# Rezoning Transportation Analysis

Petition Number: 2023-094

## Revision Log:

Date	Description
9-28-23	First Review (TM)
10-26-23	Second Review (TM)
11-30-23	Third Review (ME)

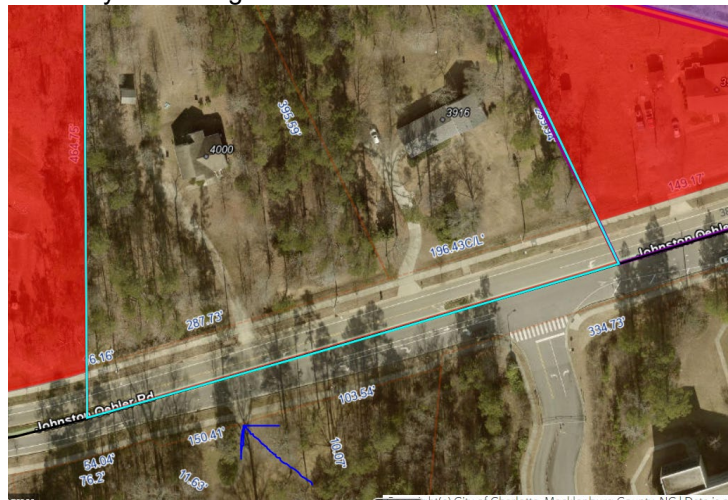
5. **Outstanding Comment from 9-28-23:** Revise site plan and conditional note(s) to commit to lining up driveway with driveway on the Southern side of the roadway.

**Clarifying Comment from 10-26-23:** Site access is to line up with the residential driveway on the southern side of the roadway. See image below.
